| FRAMING PLAN C BRIDGE RAILING                                 |                       |
| MOUNT DESERT BRIDGE OVER MOUNT DESERT<br>NARROWS TRENTON, ME. |                       |

STATE OF MAINE  
DEPARTMENT OF TRANSPORTATION  
Approved ☐ Returned for Corrections ☐  
AUG 21 1996  
Approved as noted ☒ Rejected ☐

EXPANSION DEVICE CABUT. #2 & DRAINS  
PROJ. # FSTP BH-043-1(40)X  
ITEM # 502.19, 520.242 & 520.243  
MOUNT DESERT BRIDGE OVER MOUNT DESERT  
NARROWS TRENTON, ME.  
DATE 7/26/96 DRAWING NUMBER # 96-96 2

4-PLATES-MK. A2

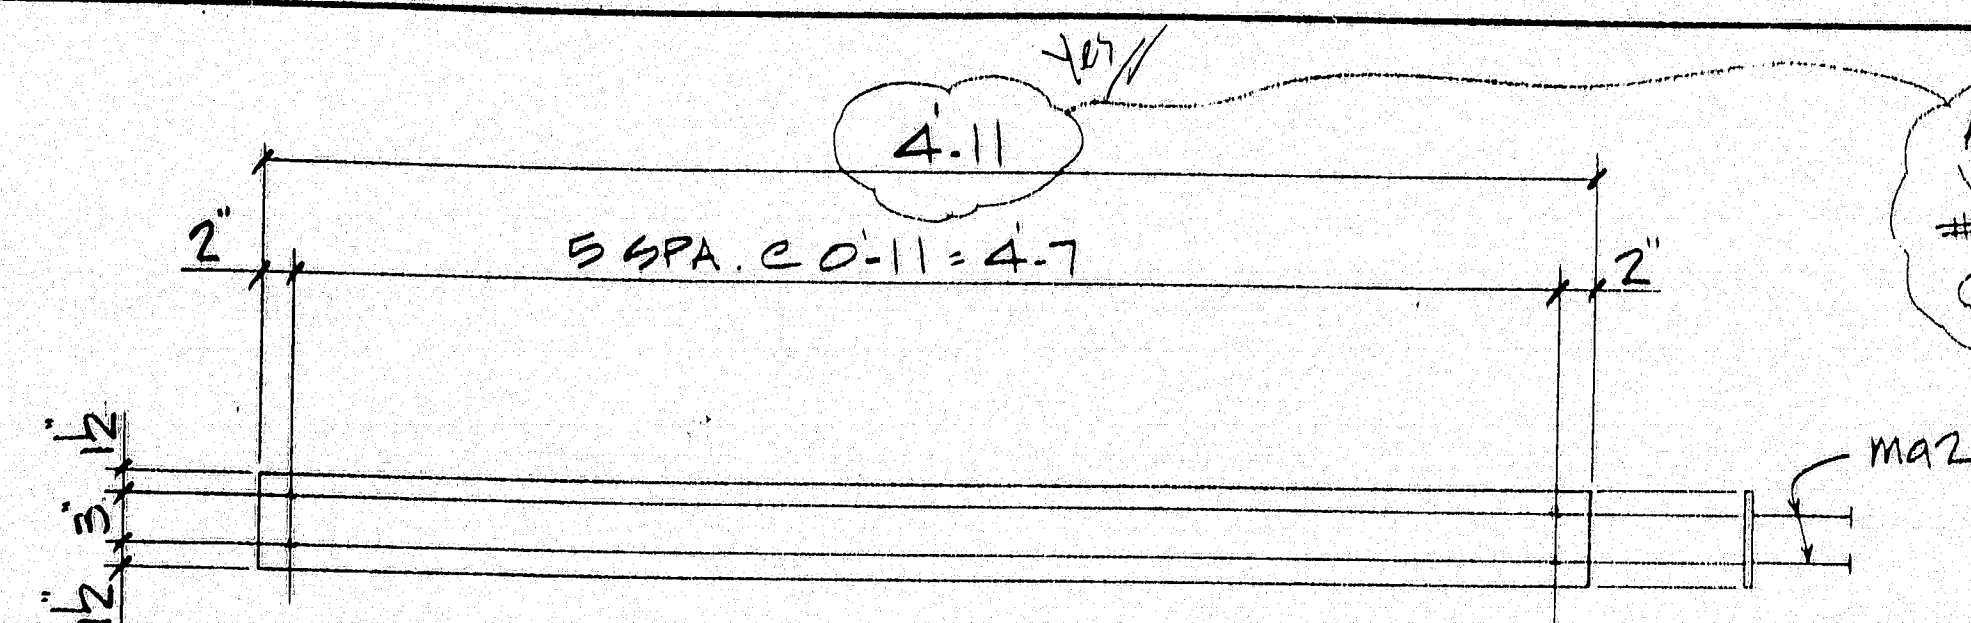
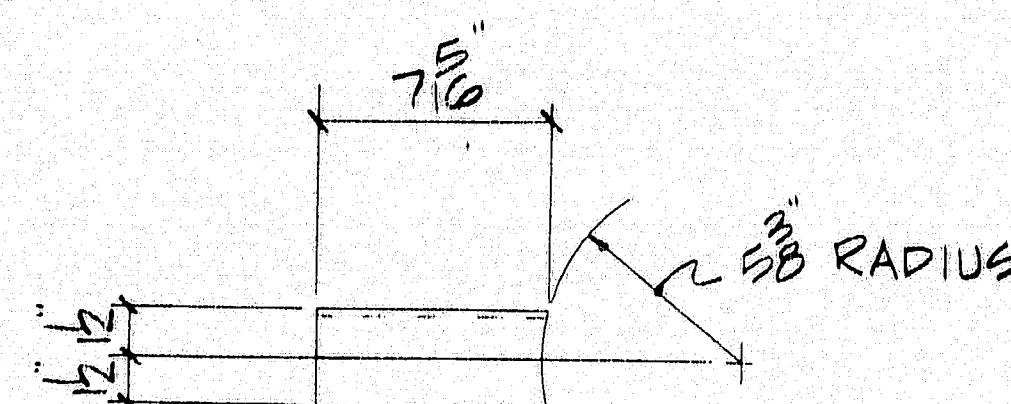
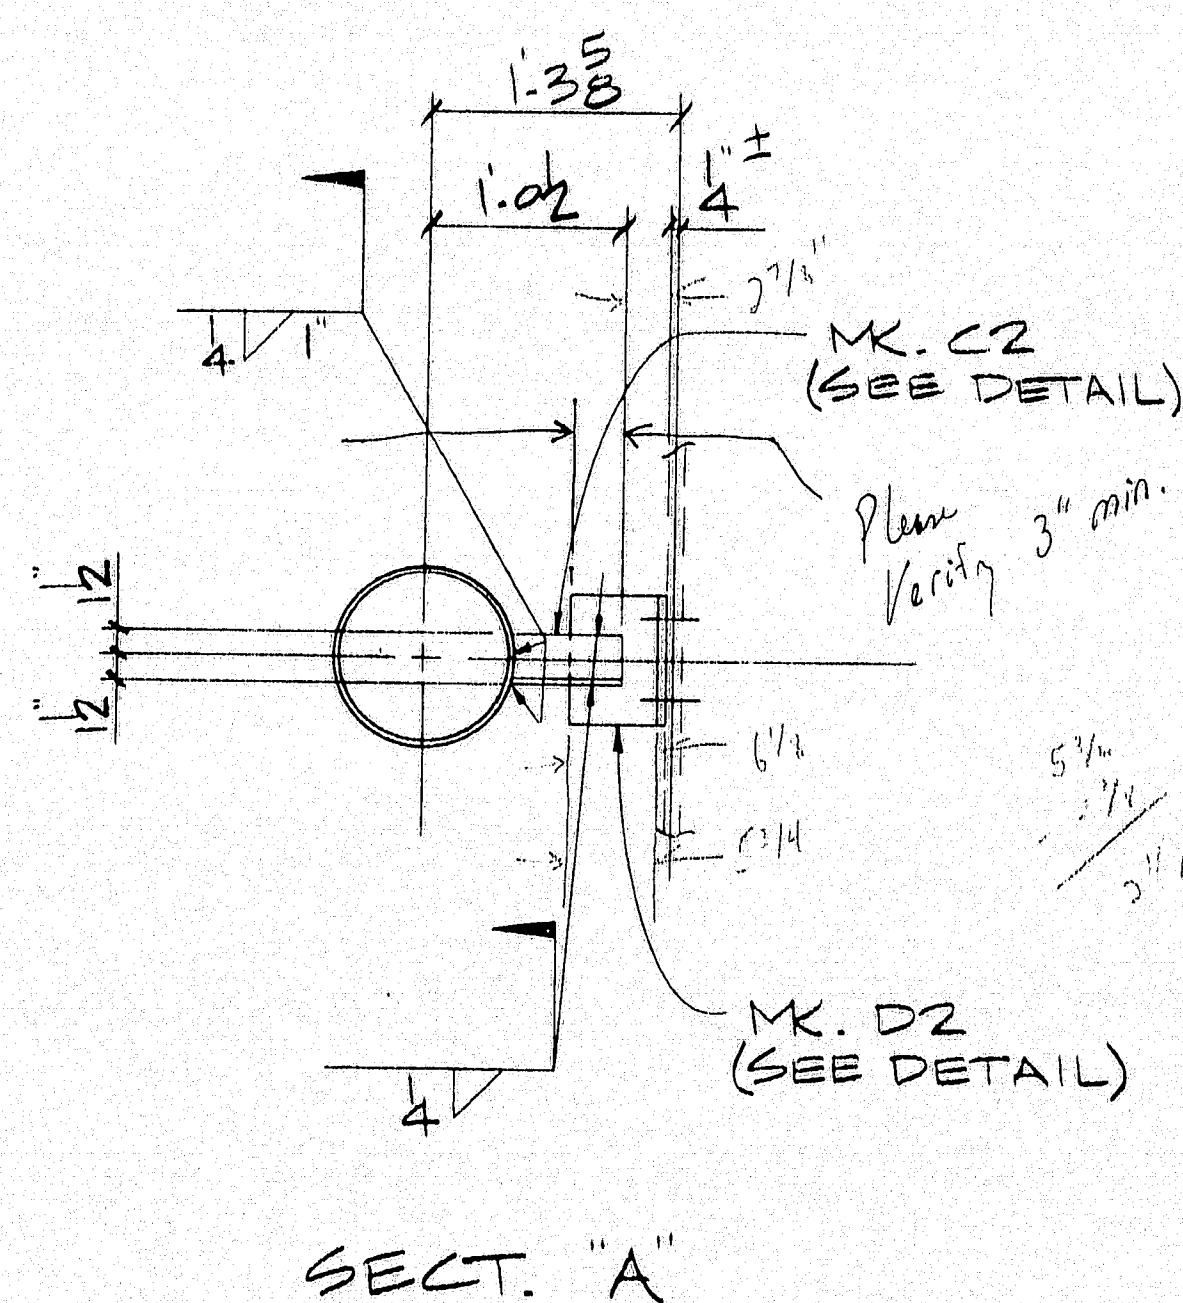
APPROVER PLEASE  
SUPPLY QUANTITY  
& LENGTH.  
Repair Plates  
Length determined in field  
by Resident and Contractor

4-BRIDGE DRAINS-MK. B2  
(GALV.)

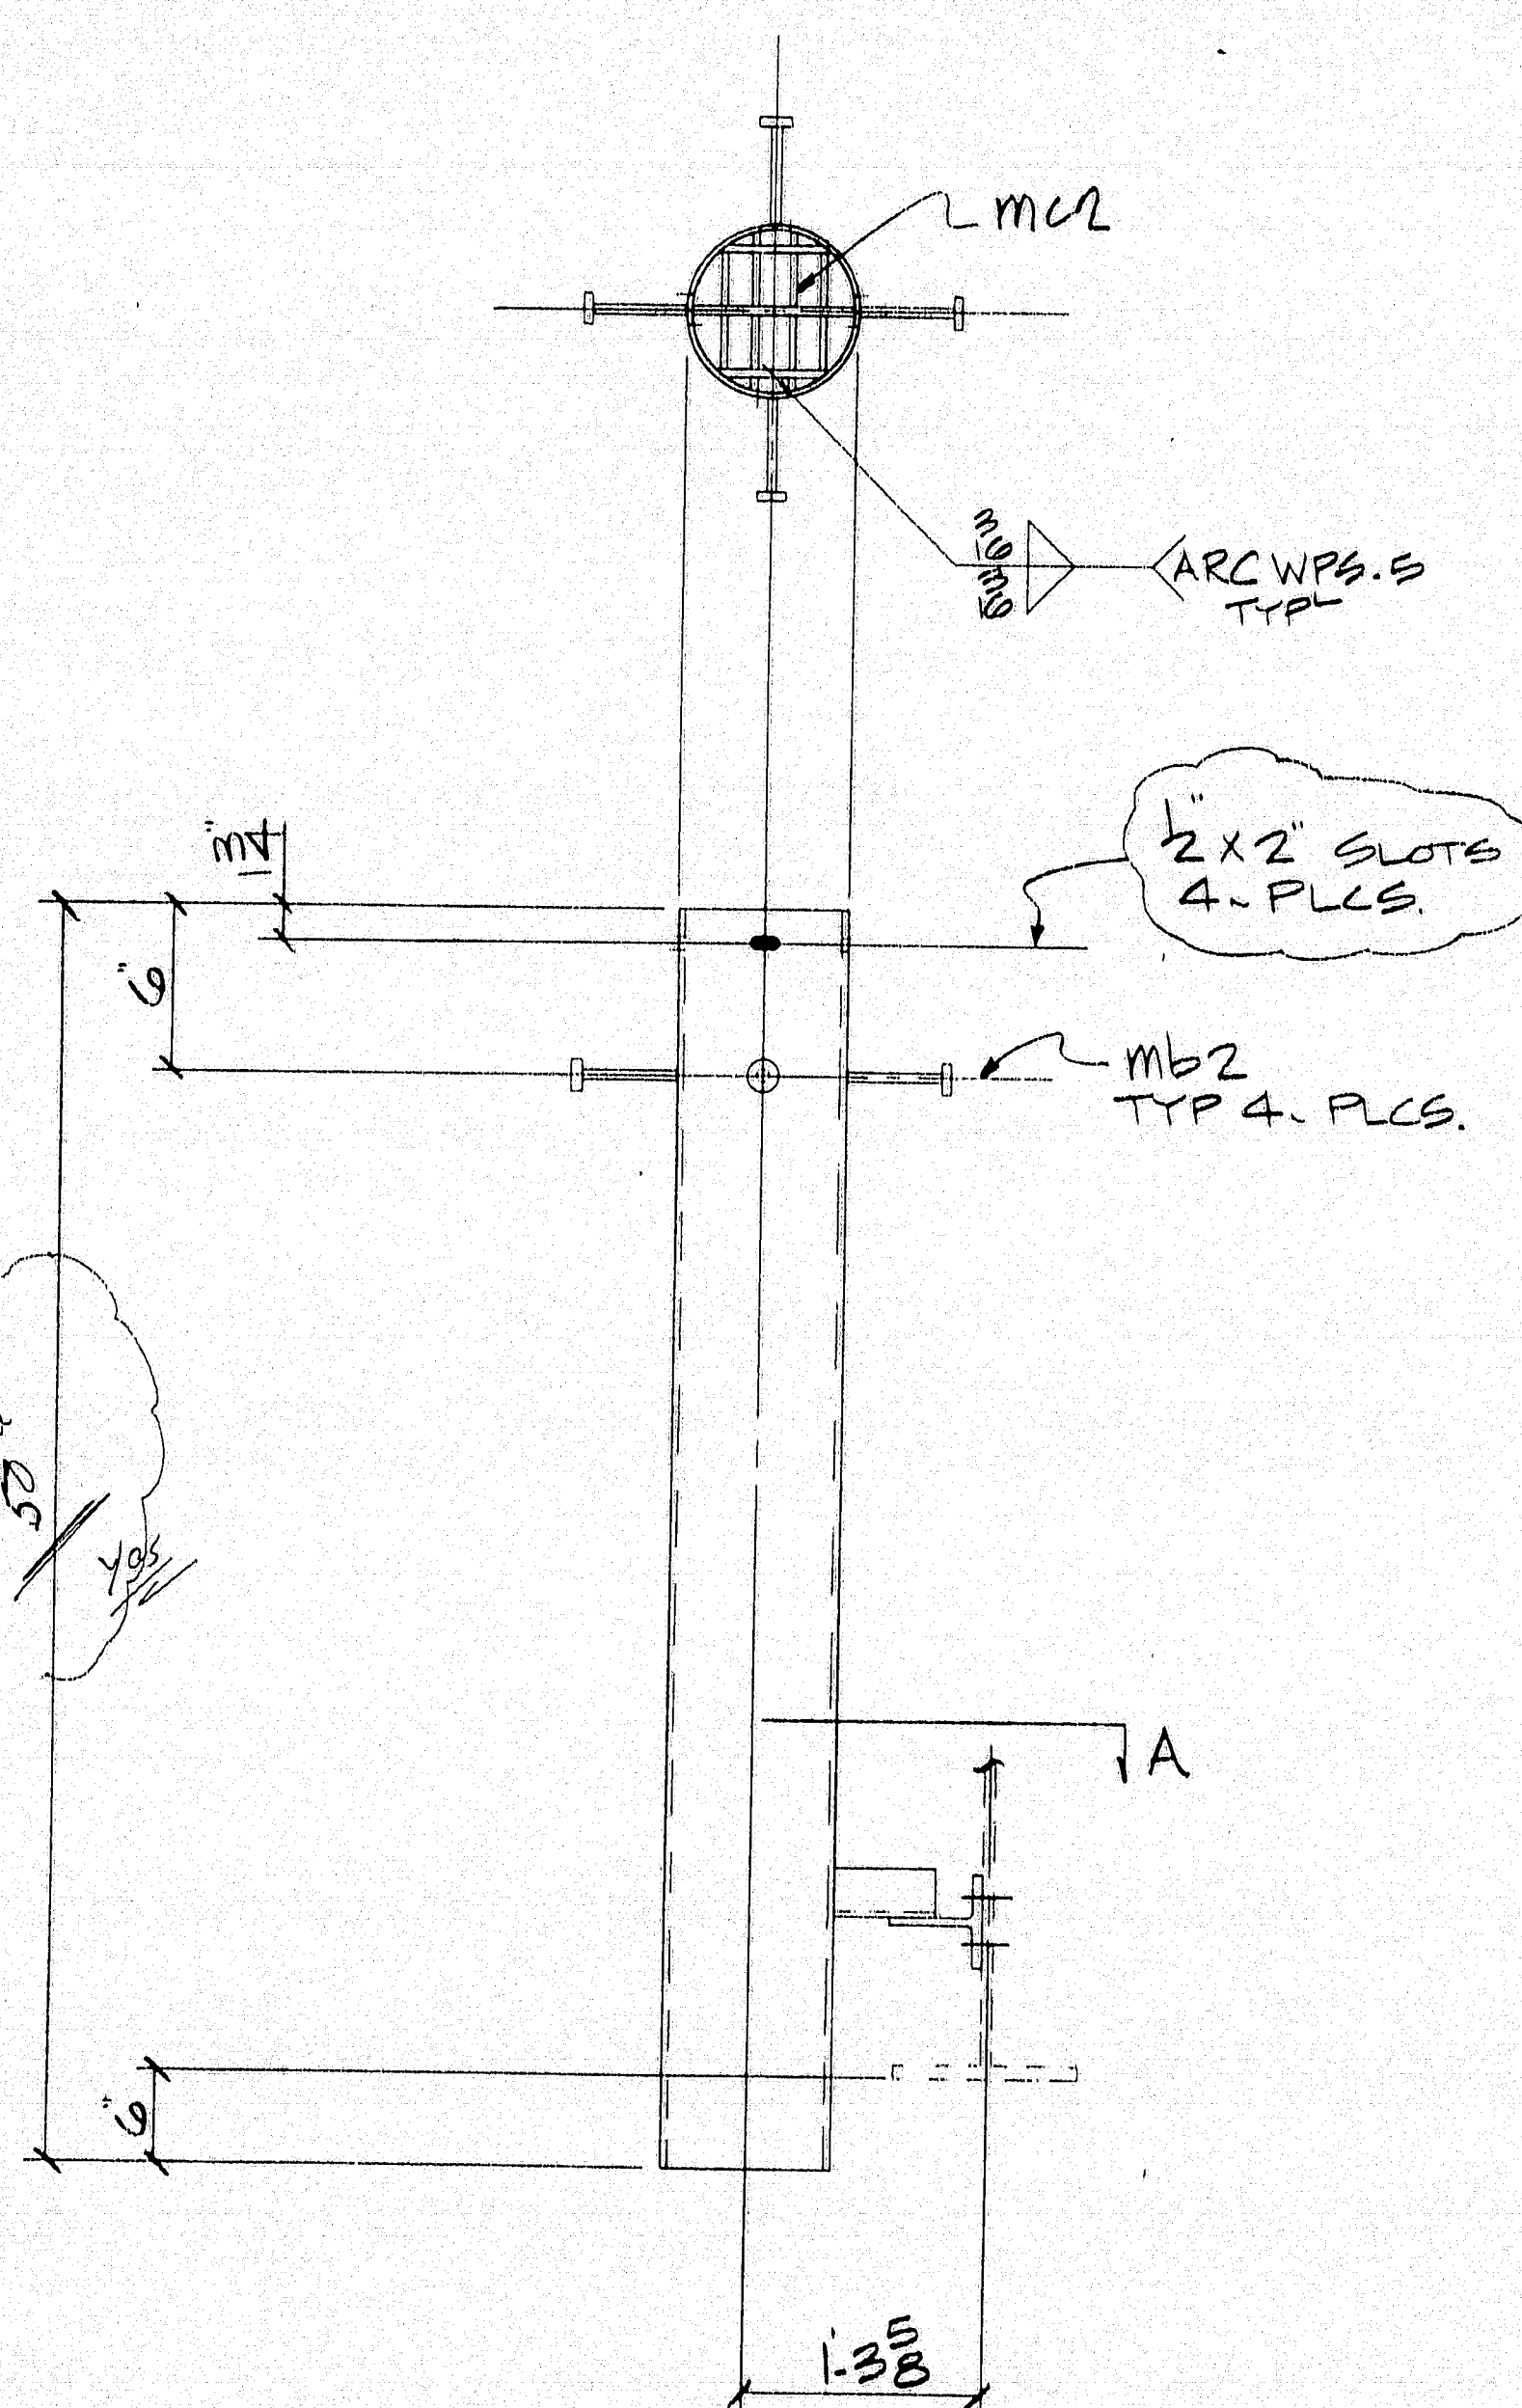
APPROVER PLEASE  
 SUPPLY!
